# *TOLEDO CITY PLAN COMMISSION REPORT*

*November 7, 2024*

SPECIAL USE PERMIT  
TOLEDO CITY PLAN COMMISSION  
REF: SUP24-00092  
DATE: November 7, 2024  
TIME: 2:00 P.M.

# SITE PLAN

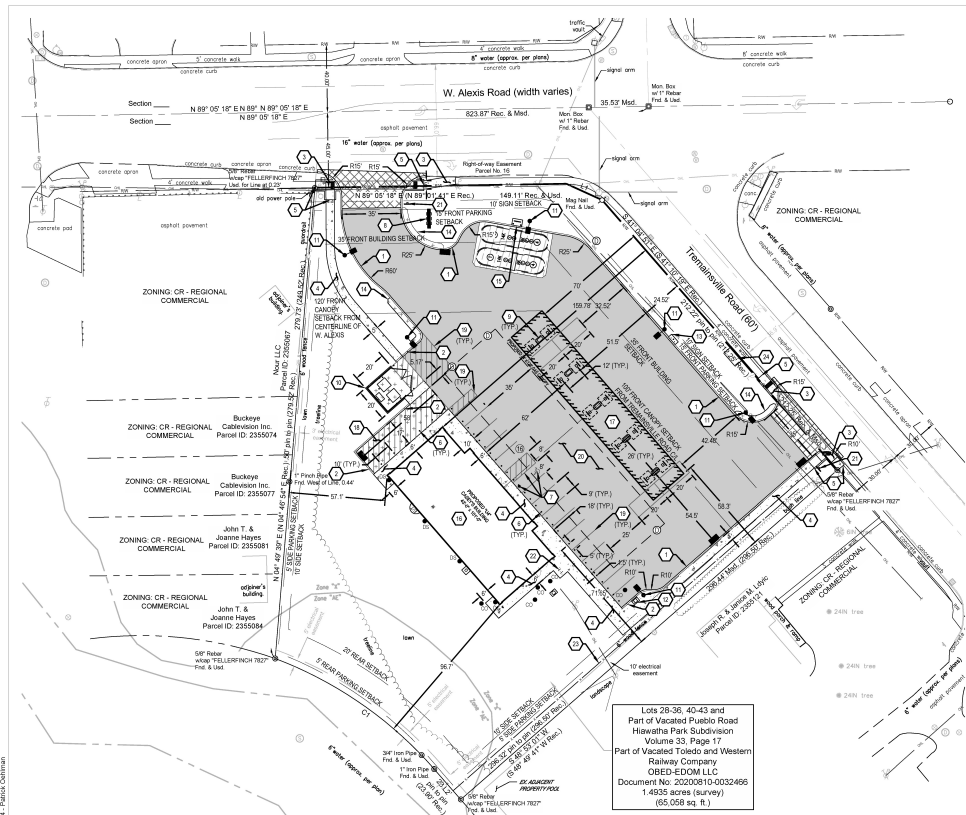
TMC§1106.0102 *Commercial Districts* sets a maximum front setback of thirty-five feet (35') in CN (Neighborhood Commercial) districts. The proposed building is set back one-hundred and sixty feet (160') from Tremainsville Road. Plan Commission supports a waiver of this requirement to allow room for the canopy to be placed in the front of the site, away from the adjacent residentially-zoned district to the south.

TMC§1107.0300 *Off-Street Parking Schedule "A"* requires a minimum of twenty-five (25) off-street parking spaces for the proposed gas station / convenience store. The site plan depicts sixteen (16) off-street parking spaces and has been deemed acceptable by the Planning Director as the applicant is offering a sheltered bus-stop on site, which offers a reduction in parking needs per TMC§1107.1407(E) *Transit Stops*.

4. An existing 6-inch diameter public water main crosses the site. Per previous discussions between the applicant and the Division of Water Distribution, this water main is to be abandoned. Show the water main on the site plan, and note the work items needed to abandon the water main. Also note the work to be completed by the Division of Water Distribution, at the applicant's expense.

38. Off-street parking shall be provided pursuant to Off-Street Parking Schedule “A,” (TMC§1107.0304). A total of twenty-five (25) parking spaces are required for this site. The submitted site plan shows sixteen (16) parking spaces. **Acceptable as depicted, given that the applicant is providing a covered bus shelter as a pedestrian amenity on-site.**

LANDSCAPE PLAN

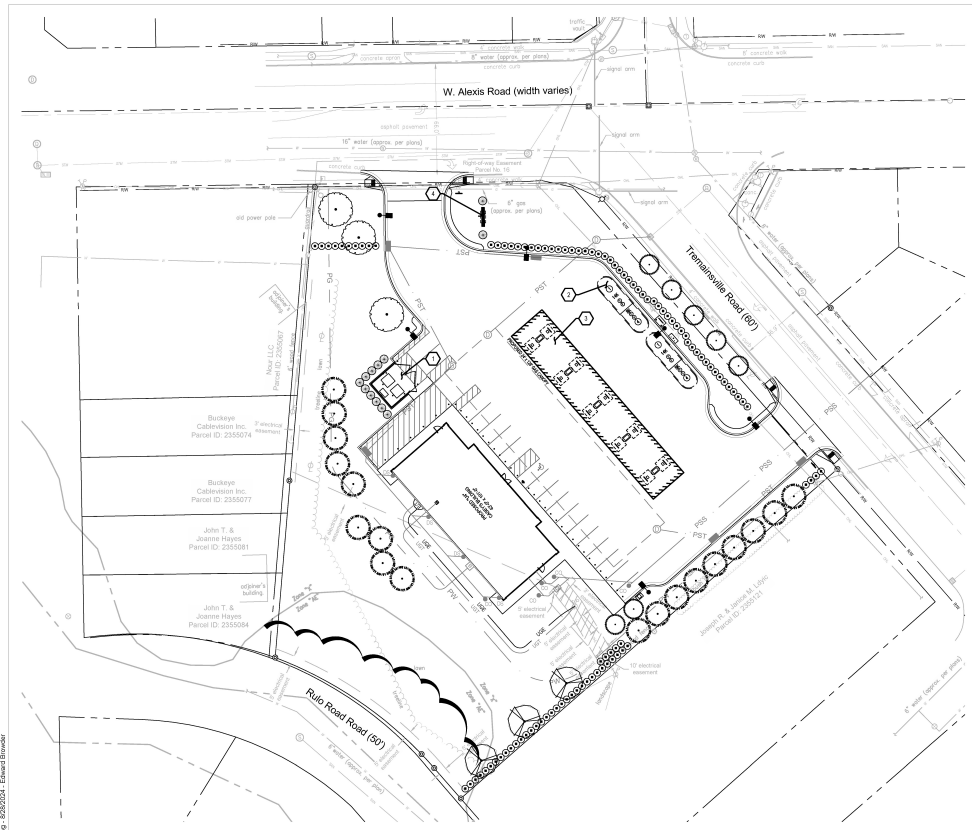
Per TMC§1108.0202 *Frontage Greenbelt*, an extensively landscaped frontage greenbelt is required along all public rights-of-way with at least one (1) tree for every thirty feet (30') of lot frontage. The lot has ±151 feet of frontage along Alexis Road and ±212 feet of frontage along Tremainsville Road, requiring a total of twelve (12) trees. The site plan provides two (2) trees along Alexis Road and five (5) trees along Tremainsville Road. An additional five (5) trees shall

be depicted in the frontage greenbelt on a revised landscape plan. Per the same code section, a solid evergreen hedge is also required to screen parking in the front of the property and prevent headlights from being seen from the right-of-way. The site plan depicts this landscape element.

The site plan must also adhere to TMC§1108.0203 *Buffer and Screening Requirements*. Existing tree canopy coverage on the site provides adequate screening along the western and southern edges of the site. A Type A landscape buffer is proposed along the eastern edge of the site with a total of twelve (12) trees, forty-two (42) shrubs, and a six-foot (6') high wooden fence. Per the code, this Type A buffer is only required where the proposed CN (Neighborhood Commercial) zoning district abuts the adjacent RM36 (Multi-family Residential) district. However, the applicant is extending the Type A buffer along the entire eastern edge of the site to help screen the adjacent single-family home (zoned CR-Regional Commercial). This landscape element requires the addition of two (2) shrubs to meet quantity requirements, but is otherwise acceptable as depicted.

Per TMC§1108.0204 *Parking Lot Landscaping*, the perimeter parking lot landscaping requirements overlap with and are satisfied by the frontage greenbelt provisions. For interior parking lot landscaping standards, the applicant is required to provide two (2) canopy trees and six (6) shrubs for each ten (10) parking spaces. The site plan depicts three (3) trees adjacent to the parking lot to meet this requirement. While not placed internally on the lot, staff is satisfied with this placement as the total impervious area on the site is being decreased by almost 4,000 square feet with the proposed parking layout, which meets the intent of this code section to reduce the heat island effect. Ten (10) additional shrubs shall be added a revised landscape plan to meet the quantity requirements for interior parking lot landscaping.

hedge to screen parking in the front of the property and prevent headlights from being seen from the right-of-way. **Not acceptable as depicted. A revised landscaping plan shall be submitted depicting an additional five (5) trees in the frontage greenbelt.**

- b. A Type A landscape buffer is required along the eastern property line where abutting the residentially zoned district. **Applicant shall extend the required Type A buffer the full length of the site's eastern edge to screen the single-family home to the east. Two (2) additional shrubs shall be added to a revised landscape plan to meet quantity requirements.**

- c. Two (2) canopy trees and six (6) shrubs are required to be installed in interior landscape areas for each ten (10) parking spaces within the parking lot. A total of three (3) trees and ten (10) shrubs are required for this site. **Not acceptable as depicted. Ten (10) additional shrubs shall be added a revised landscape plan to meet the quantity requirements for interior parking lot landscaping.**

# EAST & NORTH ELEVATIONS

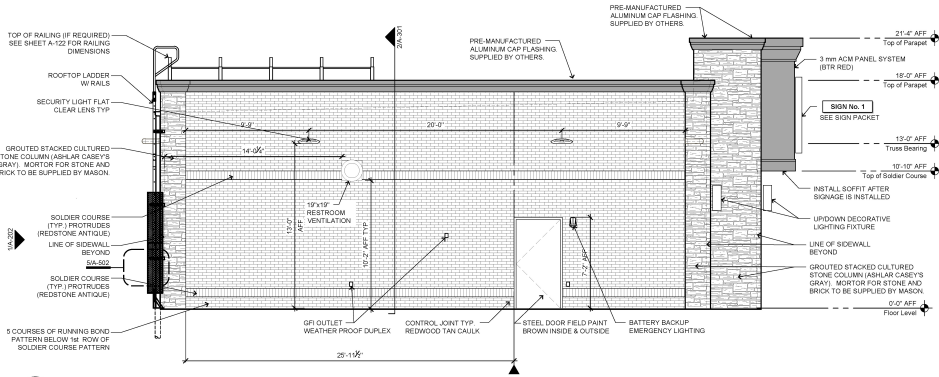
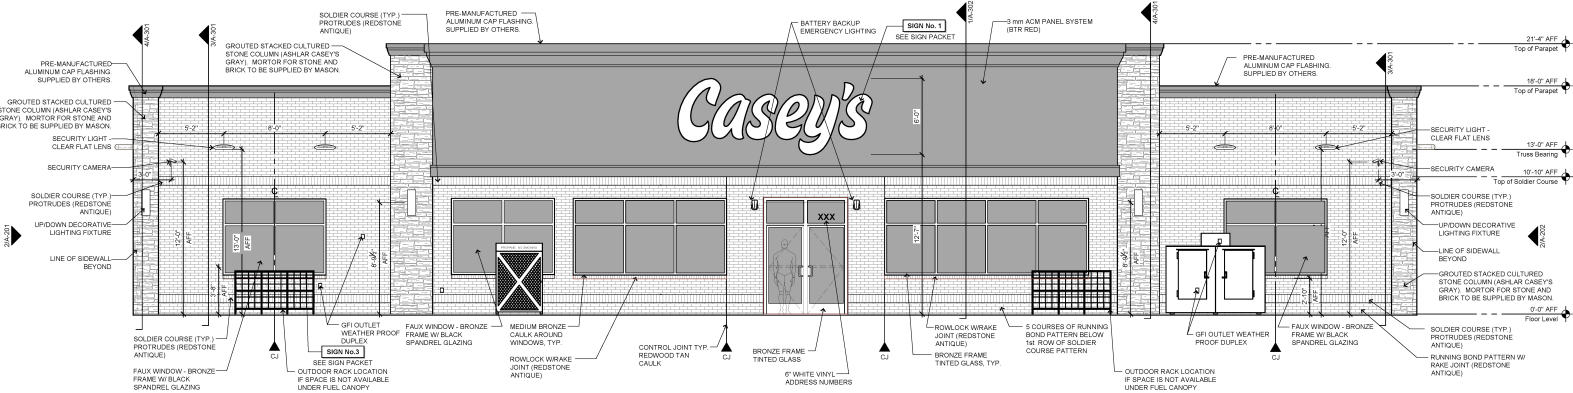
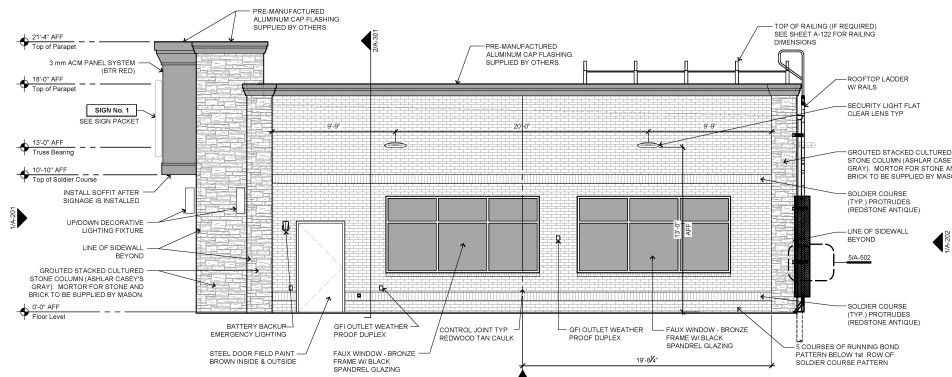
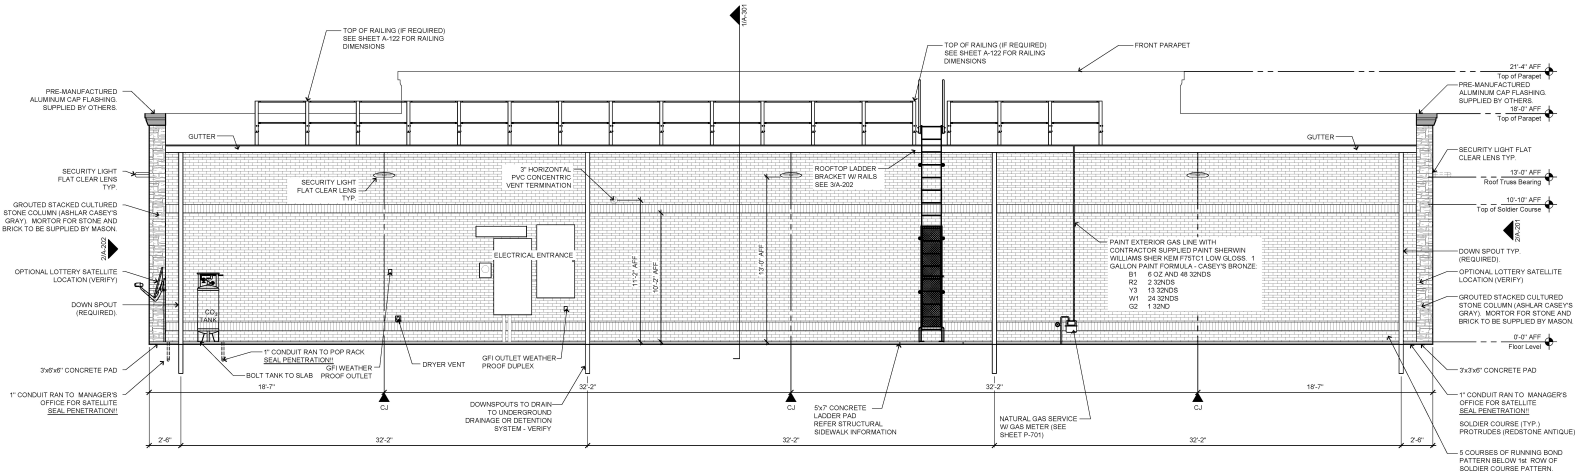
Finally, one (1) tree is required for every 1,000 square feet of building coverage to meet TMC§1108.0205 *Interior Site Landscaping*. The proposed building is 4,343 square feet and requires nine (9) additional trees, which are shown on the proposed landscape plan. This section also requires foundation plantings along all portions of the building that are visible from the right-of-way, as well as landscaping at all major entrances. Foundation plantings shall be added along the western and northern elevations, which are visible from the right-of-way.

As required under TMC§1109.0500 *Building Façade Materials and Color*, the elevations must show that at least eighty percent (80%) of each elevation visible from the right-of-way is comprised of allowable predominant materials and colors. This standard applies to the front façade,

- e. Foundation plantings shall be required along the portions of the building visible from the right-of-way. **Not acceptable as depicted. Foundation plantings shall be added along the western and northern elevations, which are visible from the right-of-way).**

47. The façade colors shall be low-reflectance, subtle, neutral or earth tone colors (i.e. gray, brown, and tan). Building trim and accent areas may feature brighter colors, including primary colors subject to the approval of the Planning Director. **Acceptable as depicted.**
